Planning Proposal to Amend Moree Plains Local Environmental Plan 2011

Proposed Rezoning of Land

Kentucky Rd, Boggabilla

Volume 4
Addendum to Report

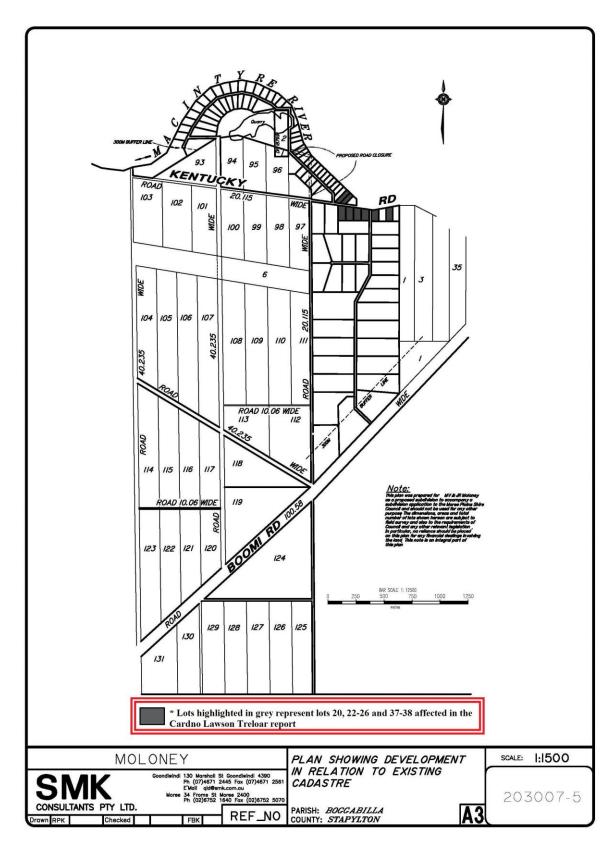
The identified Lots in the report, 20, 22-26 and 37-38 have subsequently been removed from this proposal and will remain as their current zoning, RUI – Primary Production. The exlusion of these lots from the proposal has now resulted in a total Lot amount of **84** lots, losing two lots adjoining the Macintyre River as a consequence of this amendment.

This will be demonstrated in the amended Moree Plains Shire Council (MPSC) Local Environmental Plan (LEP) zoning and lot size maps included in this addendum. Figure 2 shows the lots in question from the Cardno Report which are affected by this outcome (which also shows an original lot layout plan which has been subsequently amended since).

Figure 3: Amended Lot design

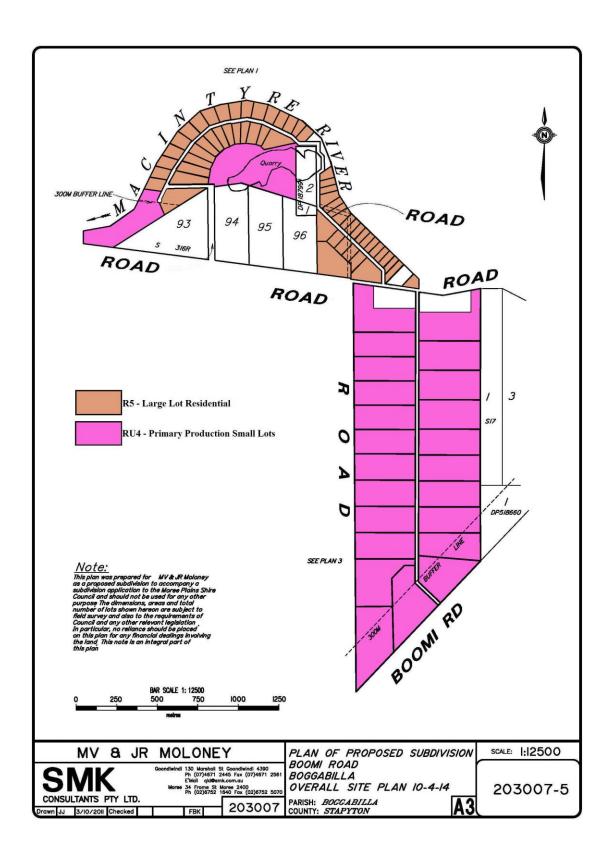
Figure 2: Lots affected by Cardno Lawson Treloar report that are to be removed from proposal. Figure 3 demonstrates the amended lot design, removing these lots raised in the flooding report from the rezoning proposal where they will remain in their current state and under RU1 Primary Production zoning.

Land Zoning Map Sheet LZN_003C, Lot Size Map Sheet LSZ_003C.

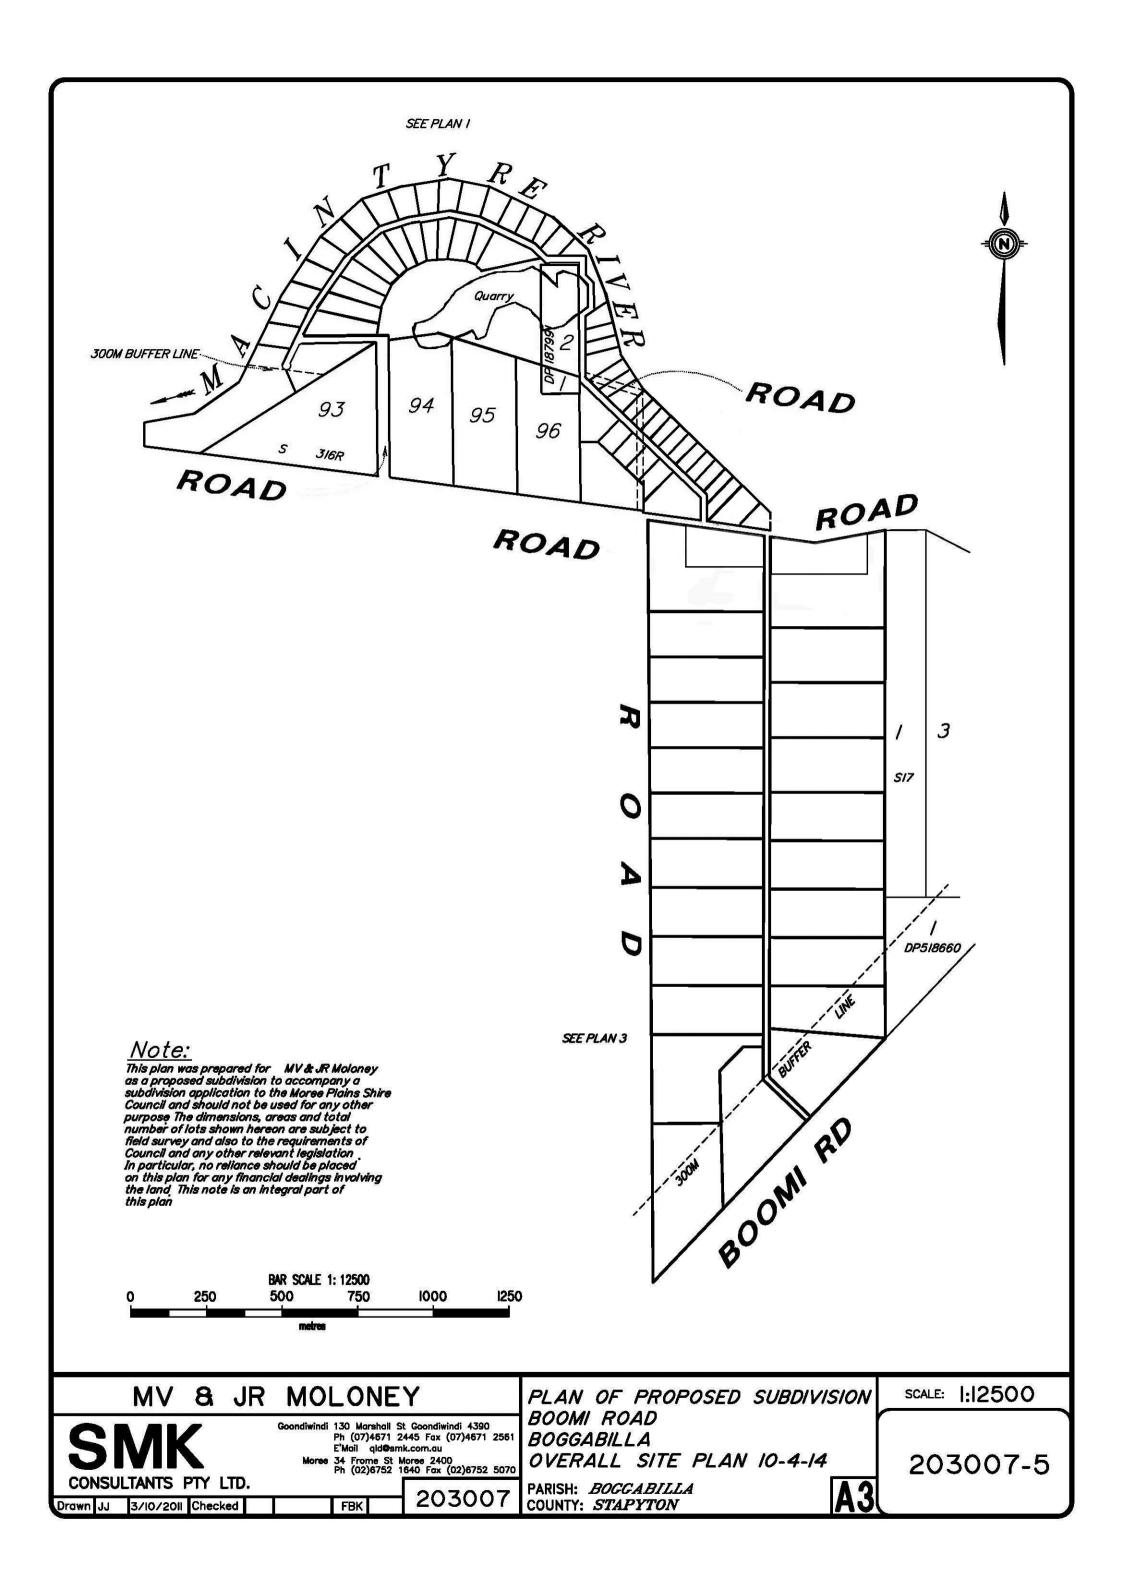
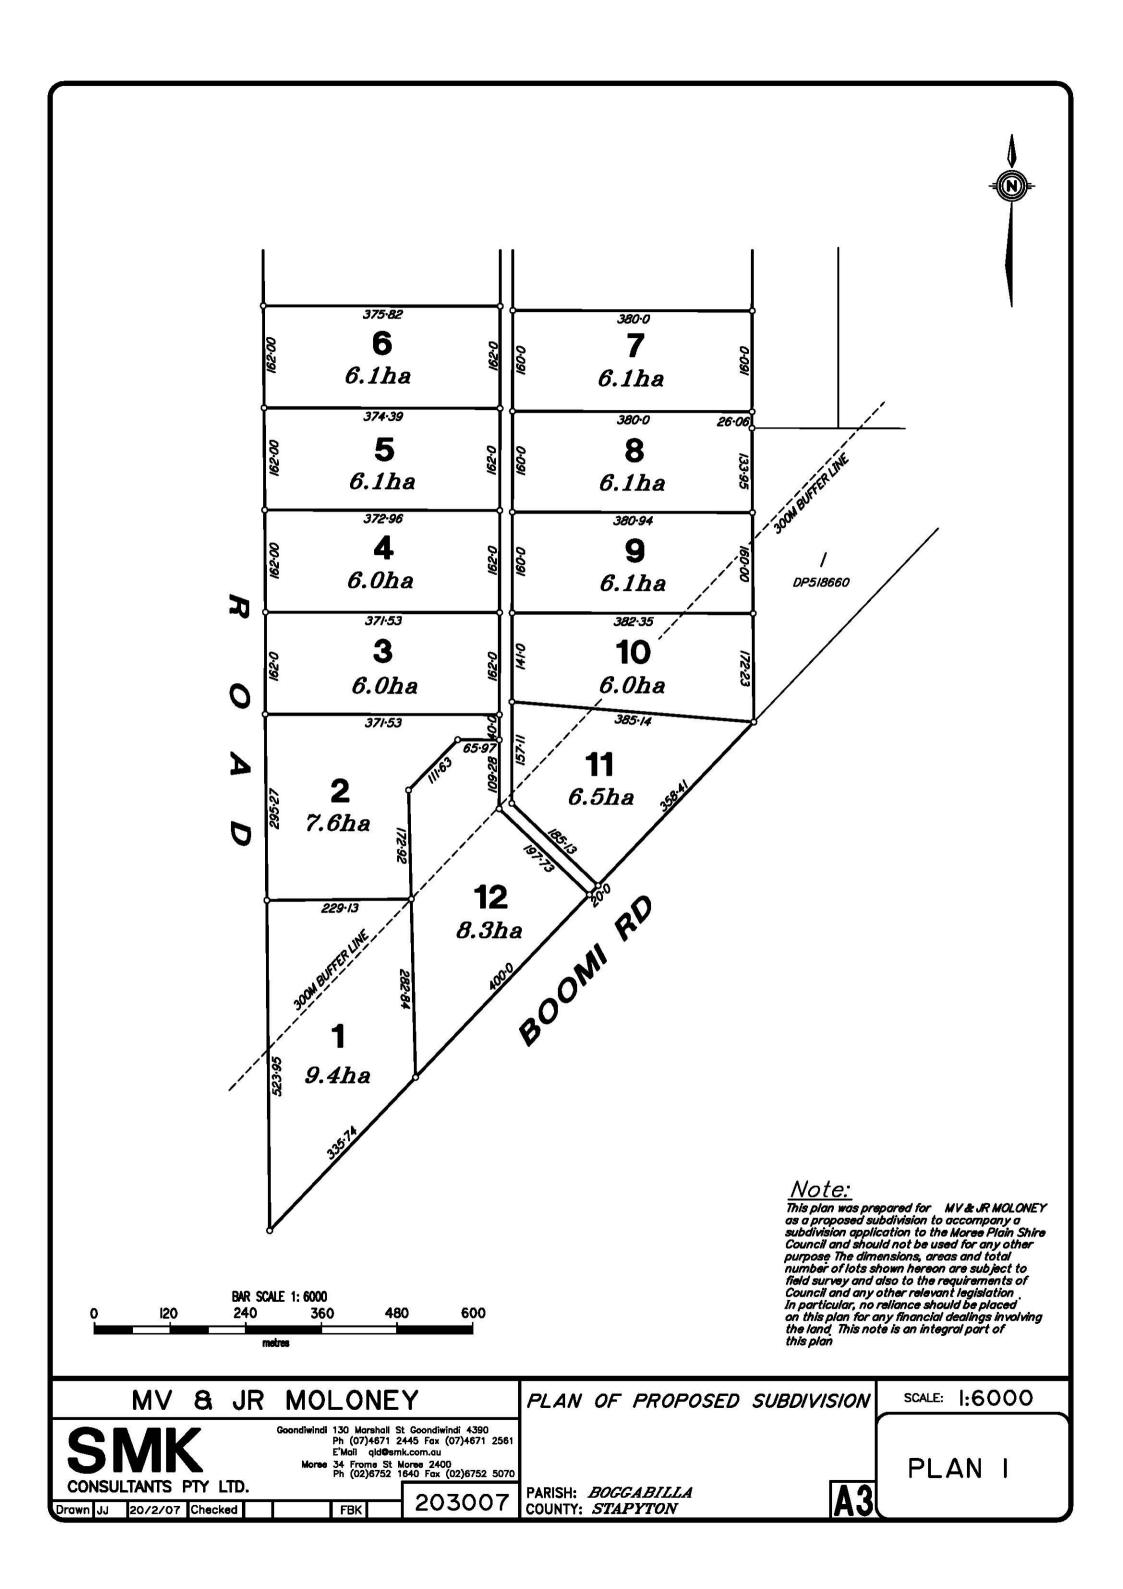
The maps attached with this addendum illustrate the changes made following this amendment to the subdivision plans.

The current and proposed MPSC LEP maps have been amended and are attached to this report, showing the area concerned with the Cardno Lawson Treloar report being removed from the Lot subdivision design and left as it present zoning, RU1- Primary Production. The proposed rezoning of lots map conducted by SMK Consultants Pty Ltd has also been amended to illustrate this change and is included just before the proposed new zoning maps. The zoning has resulted in 2 less lots than the 86 envisaged in the original planning proposal report.
